Subject: AP1000 Response to Request for Additional Information (TR03)

Response to Request for Additional Information on Technical Report Number 3

AP1000 TECHNICAL REPORT REVIEW

Figure RAI-TR03-15-1-Strain-iterated shear wave velocity profiles

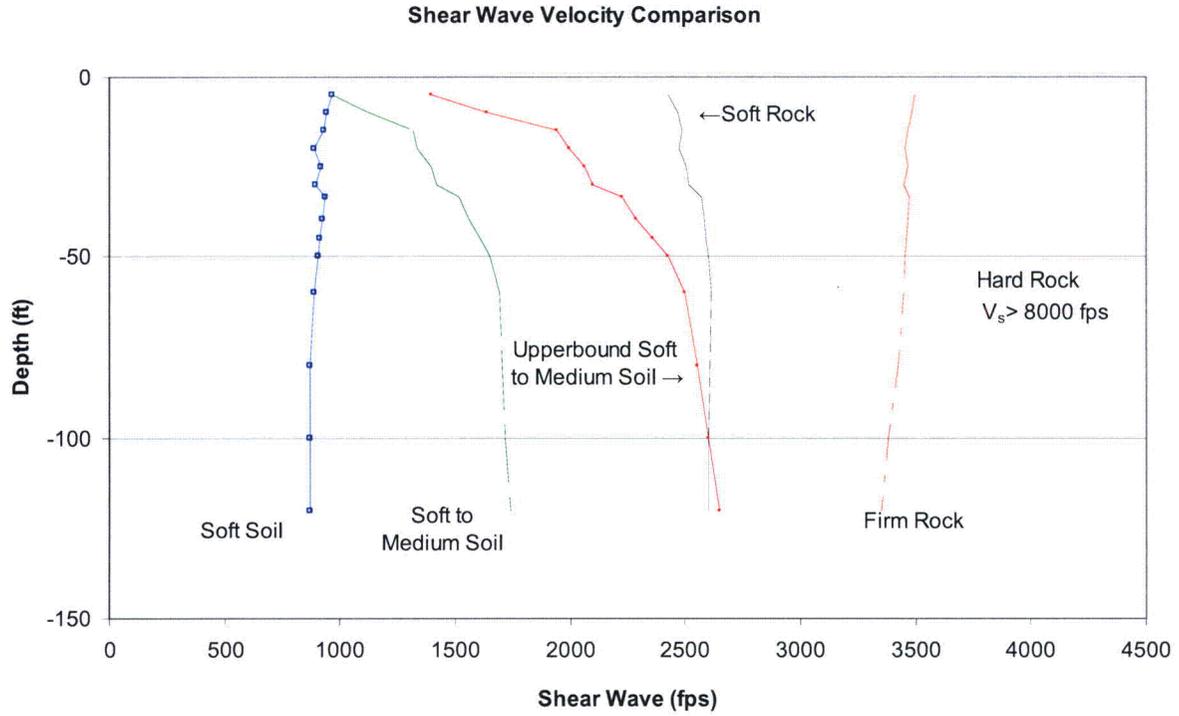
In Page 48 of 154, Westinghouse illustrated that some effects (water table, soil layering, soil degradation model, etc.) are not significant to the seismic response of the nuclear island (NI) structures. Because these results are applied for the AP1000 design, the staff requests Westinghouse provide technical basis for making these conclusions. In addition, Westinghouse needs to demonstrate the combination of these effects is also insignificant to the seismic response of the NI structures.

Westinghouse has addressed soil degradation in RAI-TR03-10. Tables of strain-iterated shear wave velocity used in the generic analyses are shown in Table 4.4.1-3 of Technical Report 03. Figure RAI-TR03-15-1 shows the bounds of these strain-iterated shear wave velocity profiles. The combination of effects of the different soil parameters is reflected in these bounds. Figure RAI-TR03-15-2 shows how a COL applicant could demonstrate that the site is enveloped by generic seismic design basis. The applicant would define its site geotechnical parameters as defined in DCD Section 2.5 and would justify why the site is within the bounds of the AP1000 generic analyses that have been considered in this technical report. These parameters would include the soil profiles used in the PSHA (probabilistic seismic hazard analysis) analyses,

which could then be compared to Figure RAI-TR03-15-1. Subsequent discussions between the COL applicant and the NRC may uncover a parameter for which more justification is required to show that the impact of this parameter on the response is small. This justification could be done with the AP1000 2D model. An example of how a 2D parametric study would be used is shown in Figure RAI-TR03-15-3 and RAI-TR03-15-4. If the parametric 2D SASSI studies show that the effect could be significant (e.g., 90% of the design spectrum, see Figure RAI-TR03-15-4) when compared to the 2D design spectra, a 3D SASSI study would then be performed. If the 3D SASSI analyses show some exceedances at the critical locations, the applicant would then proceed to show that sufficient margin exists in the design to accommodate these exceedances.

Figure RAI-TR03-021-1 - Beams at the top of the Shield Building

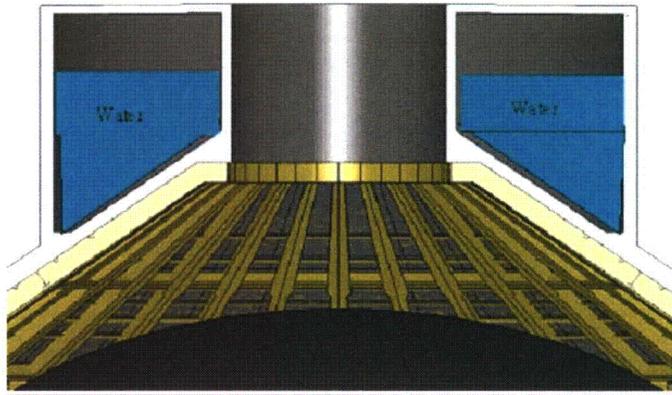
- b. The last paragraph of page 91 of 154 states "For those local flexible structures that are amplified, apply an additional acceleration to these structures equal to the difference between the average uniform amplified component accelerations and rigid body component equivalent static accelerations. These accelerations are to be considered in local design of the flexible portion of the structure but do not need to be considered in areas of the structure away from the local flexibility. They can be applied in a series of individual load vectors." It is not obvious to the staff how this methodology has been implemented, and whether the effects of increased accelerations on locally flexible structures can be ignored in areas of the structure away from the locally flexible structures. The sum total of all the flexible masses times the corresponding acceleration increments may impose non-negligible additional loads on the overall structure, in the two horizontal directions and in the vertical direction. Therefore, Westinghouse is requested to (1) describe in greater detail the implementation of this methodology, including a numerical example; and (2) provide a quantitative technical basis for the conclusion that the effects of increased accelerations on locally flexible structures can be ignored in areas of the structure away from the locally flexible structures.

In the NRC meeting of May 19 - 23, 2008 it was requested to demonstrate that the conservatism in the seismic response spectrum analysis using the fixed base 3D NI20 shell model is sufficient to reflect rocking. It was agreed with the NRC at this meeting that it would be sufficient to compare loads at the top of the shield building. Comparison is made of the bending moments in the beams that are at the top of the shield building in Figure RAI-TR03-021-1. In Figure RAI-TR03-021-2 is shown the comparison of the forces and moments in the PCS vertical wall. In all cases the response spectra analysis is conservative when compared to the time history analysis confirming the conservatism in the response spectrum analyses that will account for rocking.

SASSI Time History: 3887 k-ft
ANSYS Response Spectra: 4761 k-ft

Figure RAI-TR03-021-4 - NI10 and NI20 Vertical Response Spectra Comparisons at Node Locations 2697 (NI20) and 5633 (NI10)

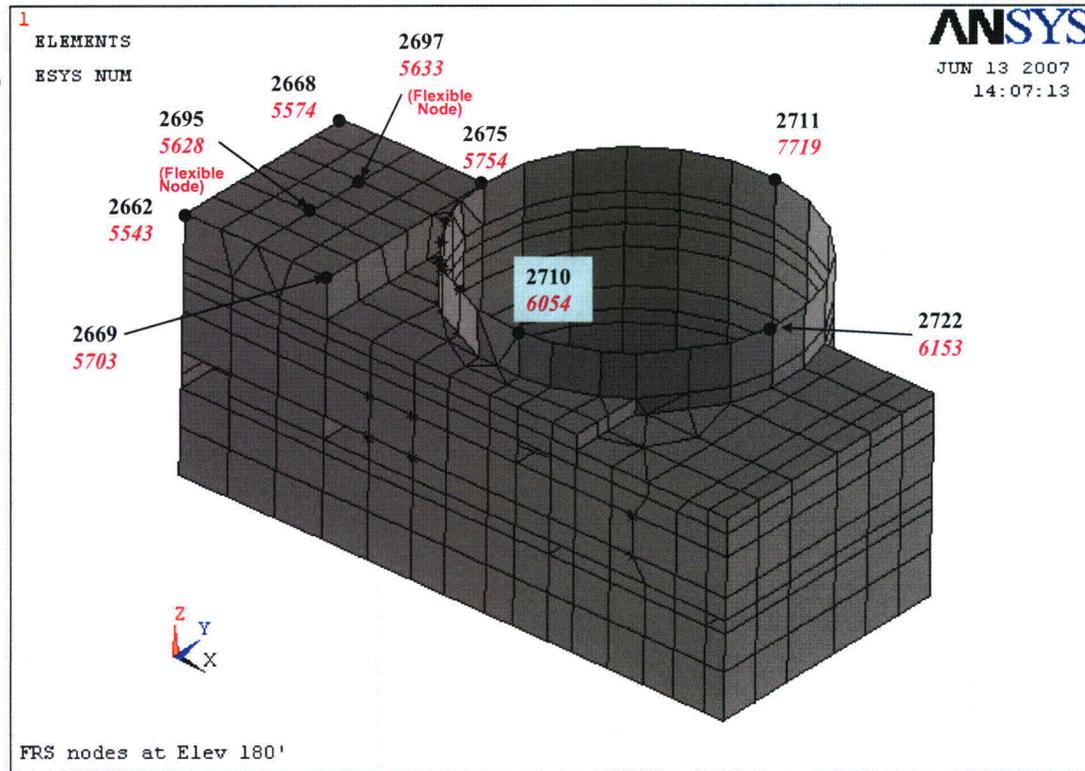
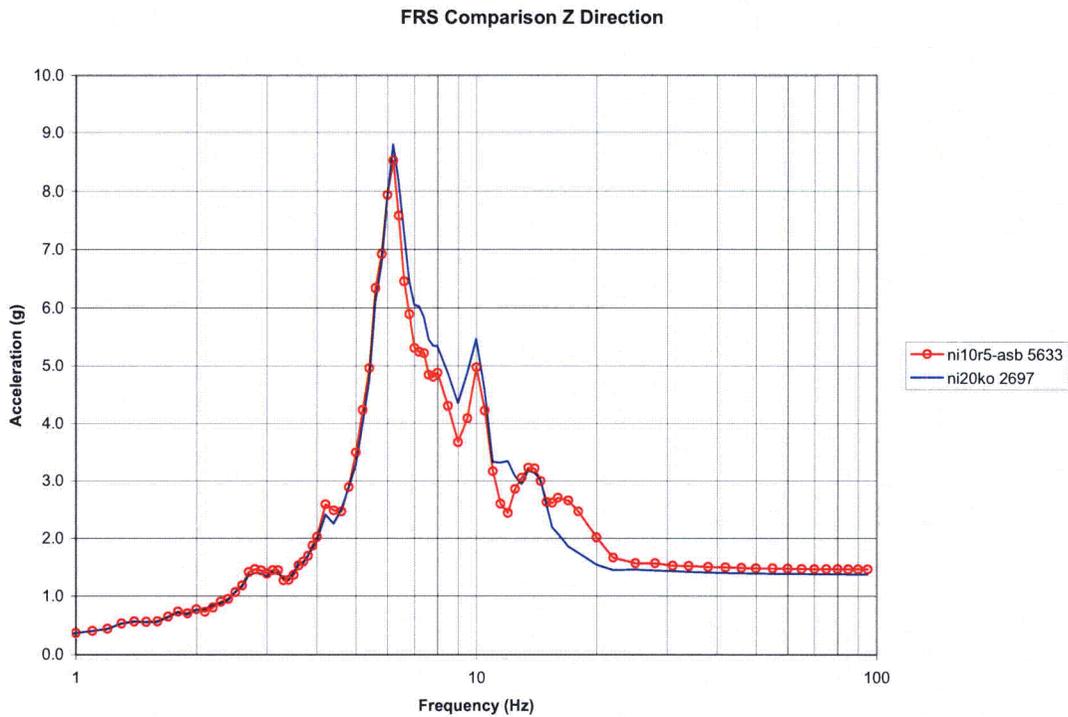
- c. The top paragraph of Page 93 of 154 states "The vertical equivalent static seismic accelerations at (Shield Bldg) elevations 294.93 ft and 333.13 ft are obtained directly from the maximum time history results by taking the average of locations at opposite ends of a diameter. The vertical accelerations from the 3D finite element model at the shield building edges at these elevations are significantly influenced by the horizontal loading. If they are used for the vertical equivalent accelerations, the horizontal response would be double counted in the vertical direction." It is not obvious to the staff how this methodology has been implemented, and whether it is even appropriate. Therefore, Westinghouse is requested to submit a numerical example, based on elevation 333.13 ft of the Shield Building, to demonstrate the implementation of this methodology. In this example, please also include the vertical acceleration value that would be obtained if this methodology was NOT implemented.

In the NRC meeting of May 19 - 23, 2008 it was requested to show that the NI20 is adequate to reflect the floor flexibility. In Figure RAI-TR03-21-4 is shown a comparison of vertical response spectra (5% damping) associated with the roof in the fuel building area (see Figure-TR03-21-3). The vertical response spectra closely match demonstrating the adequacy of the NI20 model.

Figure RAI-TR03-022-01 – Comparison of Time History Displacements using Double Integration and Fast Fourier Transforms

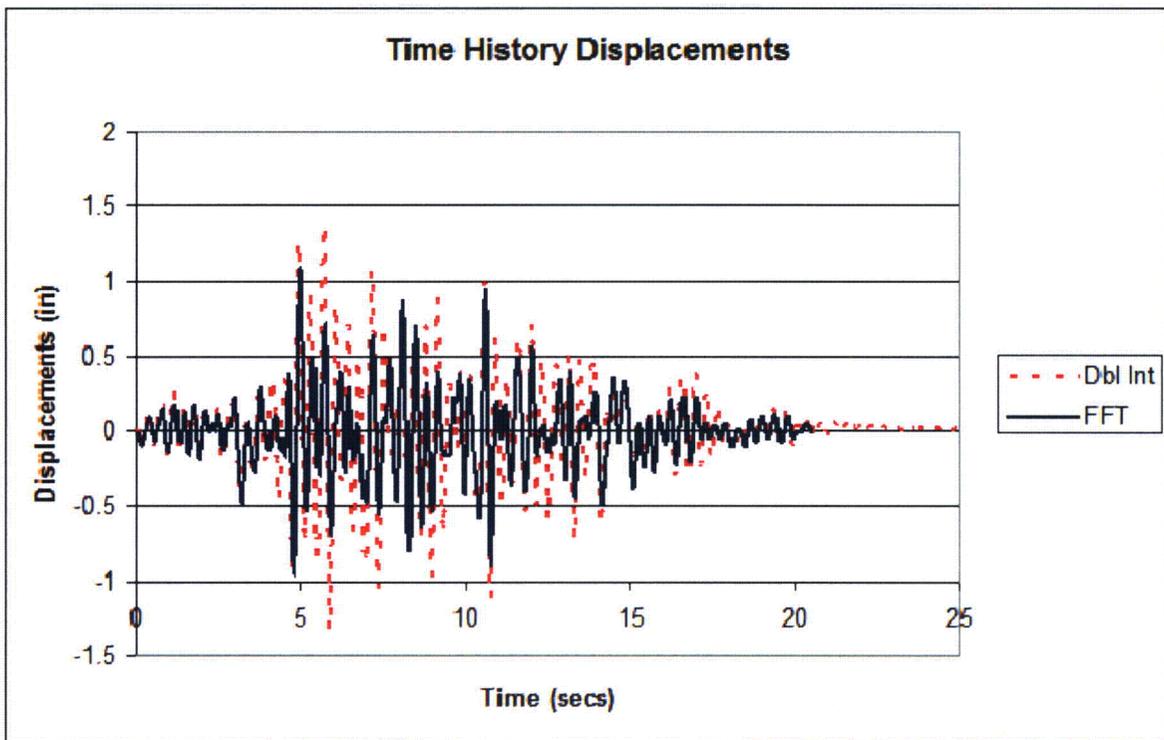
- a. Are the deflections in the tables a consistent set, based on the worst-case time history result, or are they an envelope of maximum deflections from all the time history results?
- b. How do these tabulated deflections compare to the corresponding deflections obtained from the equivalent static acceleration analyses? Please provide a tabulated comparison, and an explanation of any significant differences.

In Figure RAI-TR03-022-01 is presented a comparison for the baseline double integration (old, Dbl Int) method compared to the FFT (new method) shown for the soft to medium soil case at the top of the shield building.

Figure C-1 – FRS Comparison at Base of SCV on CIS at RPV Center

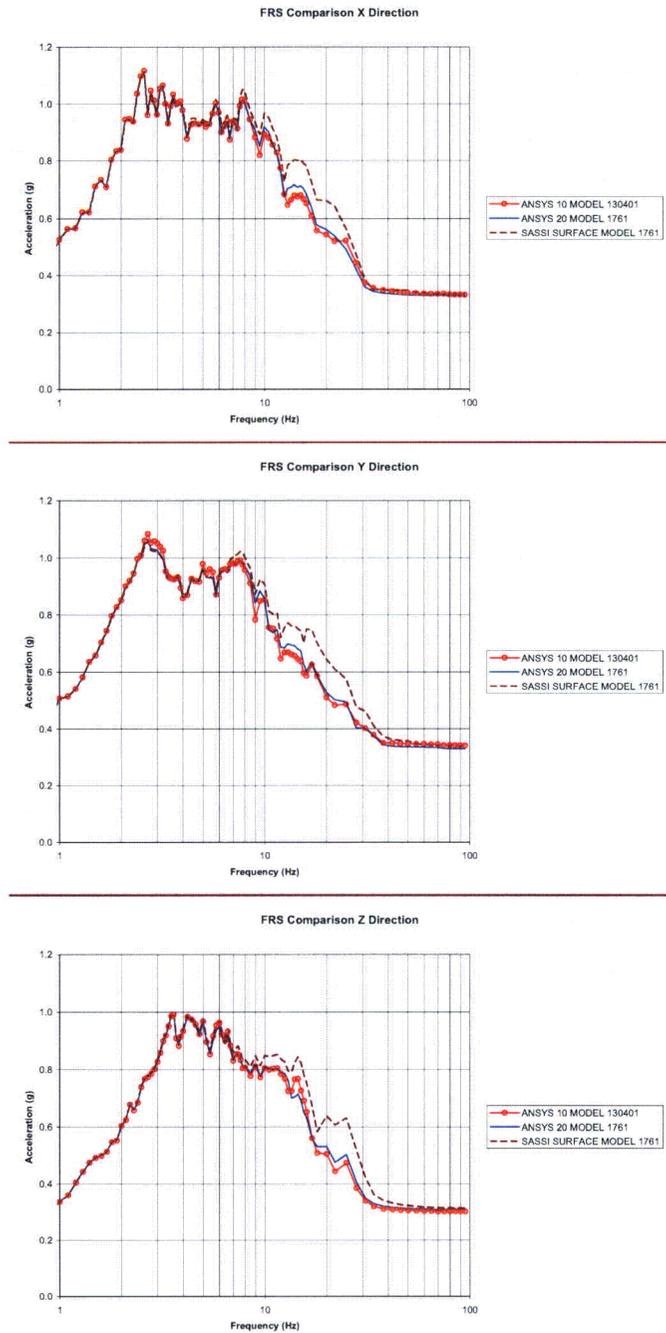
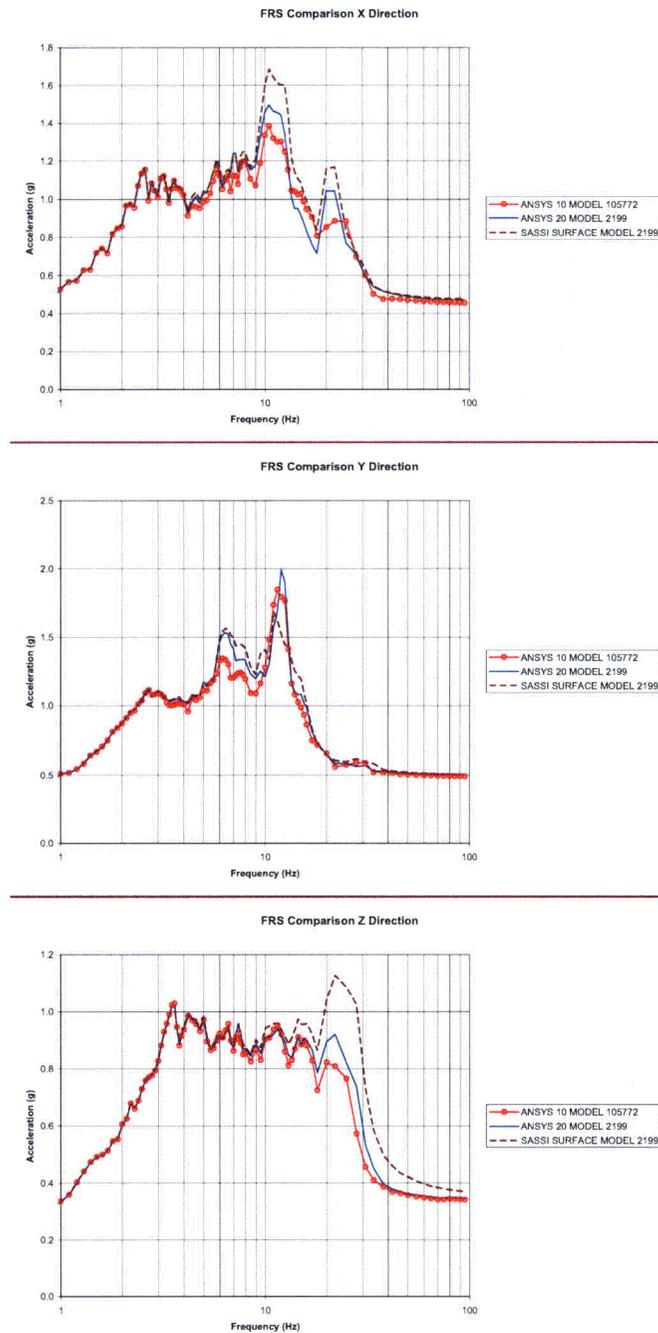
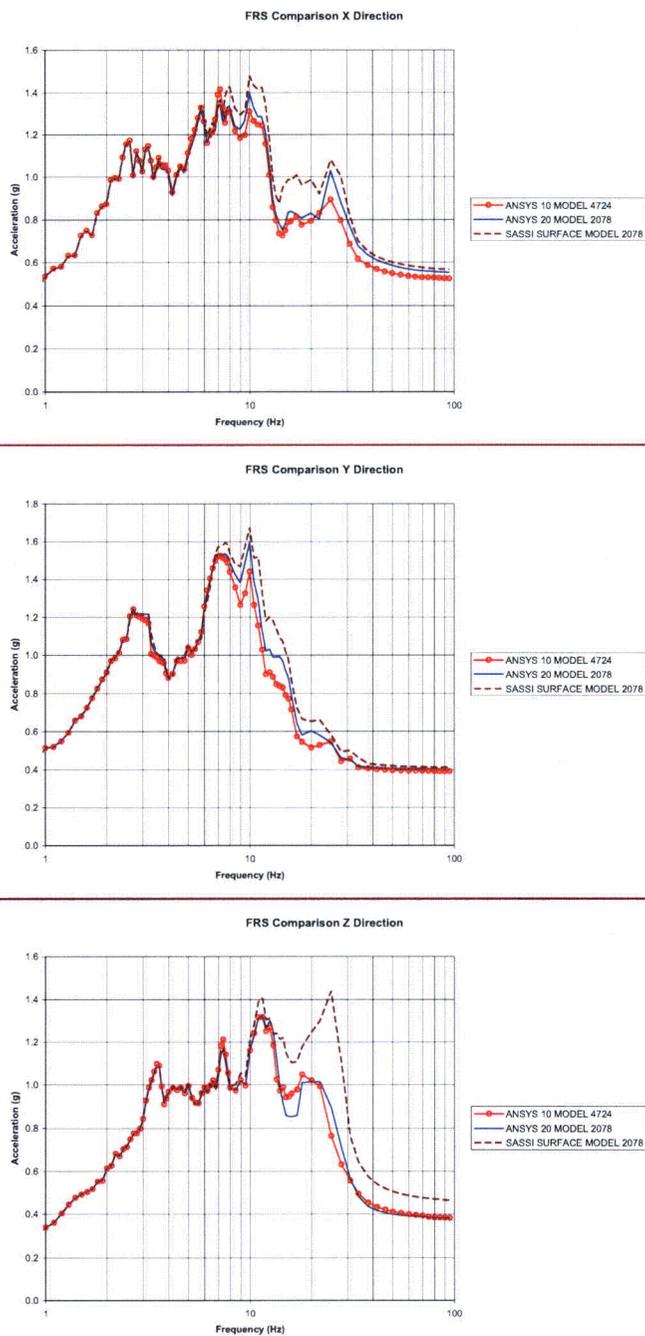
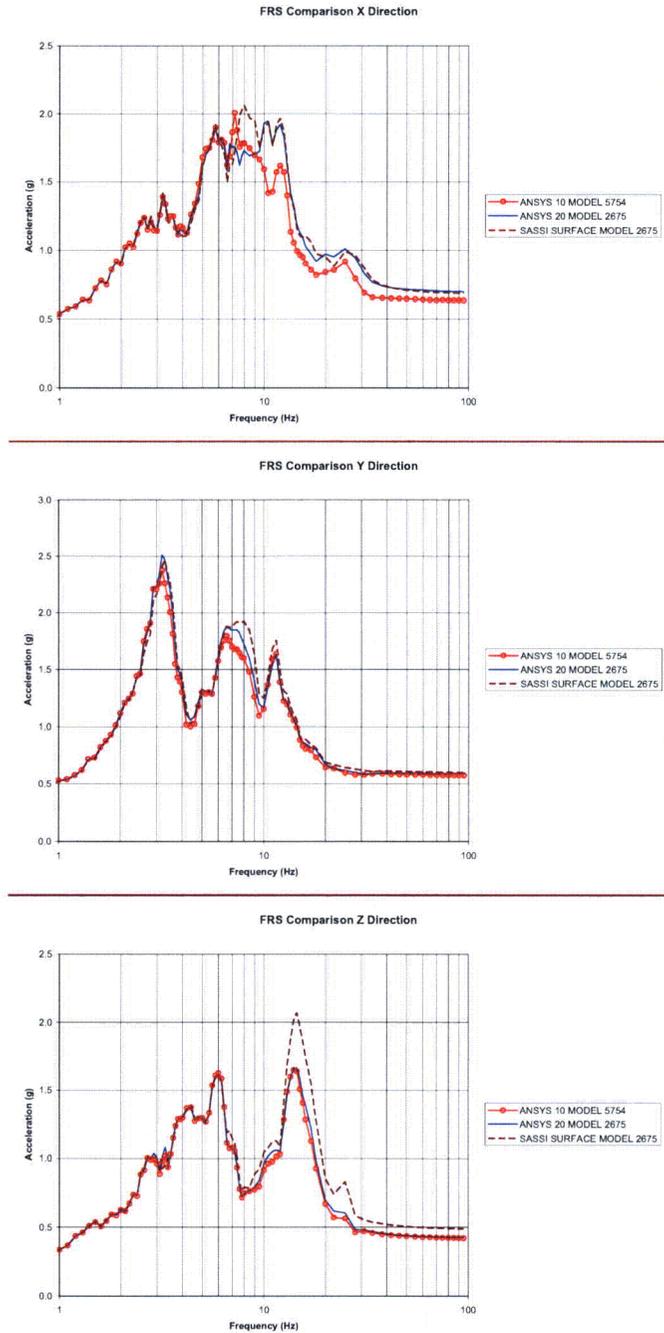
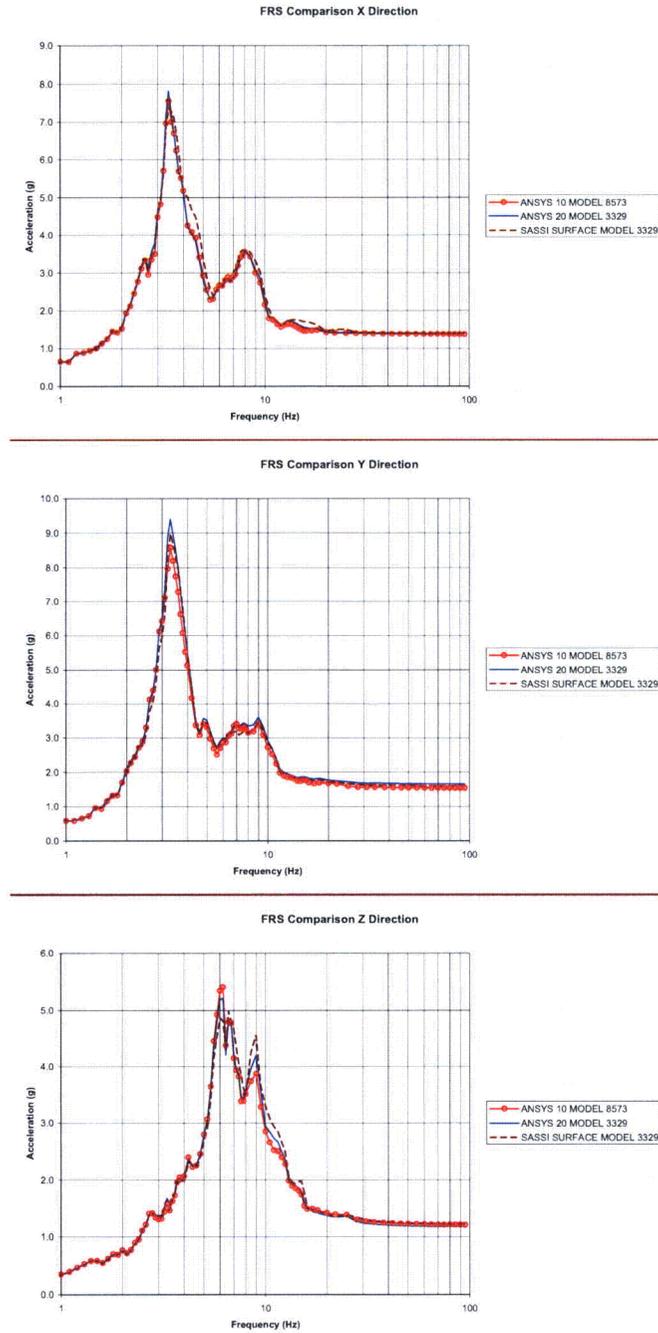
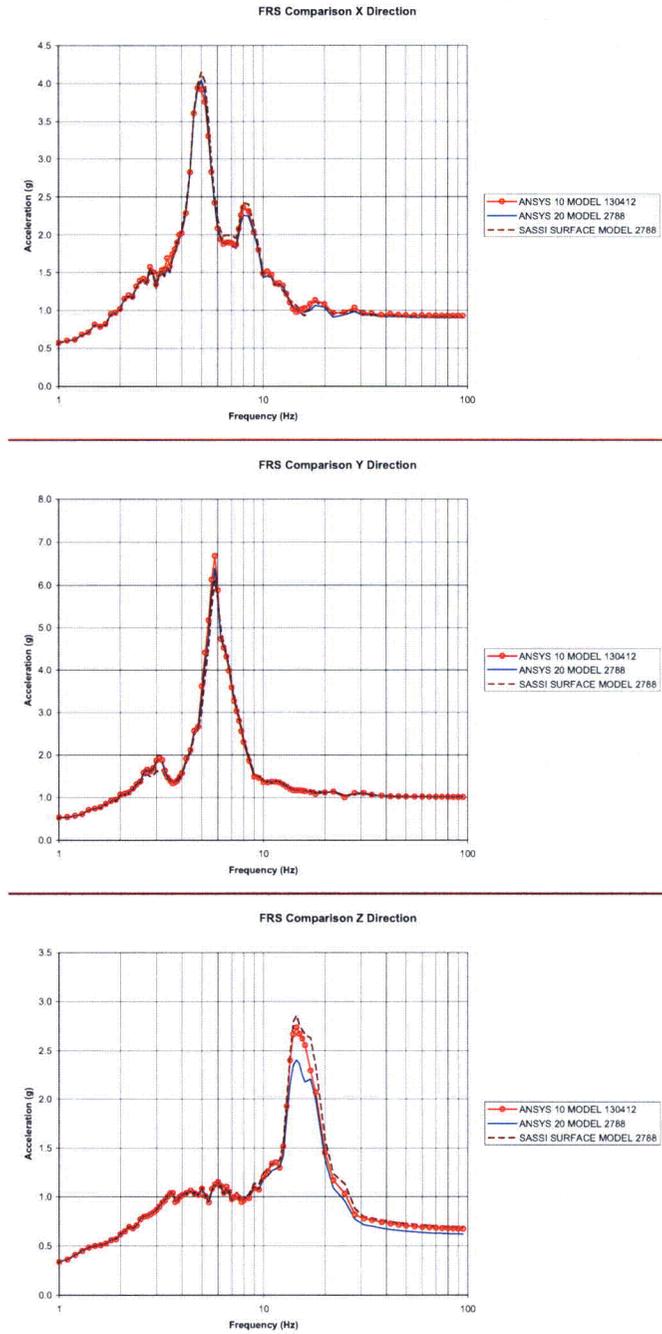
- c. Explain what studies were performed to establish that the NI10 model refinement is sufficient to accurately account for high frequency response effects at all critical locations. It is not obvious from the results shown in Figure C-1 that convergence with element size has been achieved.

Based on discussions in the NRC meeting on May 19-23, 2008, revisions to wording in Appendix C of the technical report was modified to state that the NI20 model has higher (conservative) results in the high frequencies compared to the NI10 model.

As seen from the comparison (see Figures C-1 to C-6), for the horizontal response, the SASSI and ANSYS results for NI20 are very similar to about 15 Hz horizontal and about 10 Hz vertical. At the higher frequencies SASSI calculates higher accelerations. The NI20 model uses solid
